Access Compliance Report

Public Rights-of-Way

(Curb Ramps)

Intersection ID: 46499	Main Street: WHITEBURN_CT	Cross Street: BALTRAY_RD	Location: SW
ADA ID: 4EE80C DFA451	Ramp Type: Perp	Initial Pass/Fail: Fail	Overall Compliance: No
Severity Score: 33.75			
Codes/Mitigation Info/Possible Solution		Field Measurements/Component Compliance

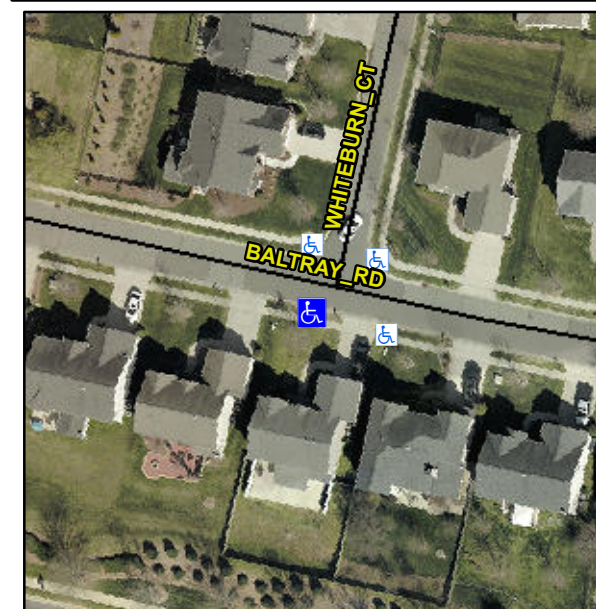
Not Found, R304.5.1, R304.2.2

Compliance	Description	Data	Compliance	Description	Data
N/A	Ramp Length (in)	47.0	No	Ramp Slope (%)	12.5
No	Ramp Width (in)	47.5	Yes	Ramp XSlope (%)	1.0
N/A	Flare Type LT	N/A	N/A	Flare Type RT	N/A
N/A	Flare Slope LT (%)	N/A	N/A	Flare Slope RT (%)	N/A
N/A	Flare Traversable LT?	N/A	N/A	Flare Traversable RT?	N/A
N/A	Landing Length (in)	N/A	N/A	DWS Provided?	N/A
N/A	Landing Width (in)	N/A	N/A	DWS Contrast?	N/A
N/A	Landing Slope (%)	N/A	N/A	DWS Length (in)	N/A
N/A	Landing X Slope (%)	N/A	N/A	DWS Full Width?	N/A
N/A	Landing Curb? (Y/N)	N/A	N/A	DWS Offset (in)	N/A
N/A	Shared Landing?	N/A			
N/A	Gutter Ponding?	N/A	N/A	Gutter Slope (%)	N/A
N/A	Gutter Lip Ht (in)	N/A	N/A	Gutter X Slope (%)	N/A
N/A	Painted X Walk1?	No	N/A	Painted X Walk2?	N/A
	X Walk 1 Direction	To NE		X Walk 2 Direction	N/A
N/A	X Walk 1 Width (in)	N/A	N/A	X Walk 2 Width (in)	N/A
	X Walk 1 Slope (%)	2.4		X Walk 2 Slope (%)	N/A
	X Walk 1 X Slope (%)	1.0		X Walk 2 X Slope (%)	N/A

Remove & Replace Entire Ramp.
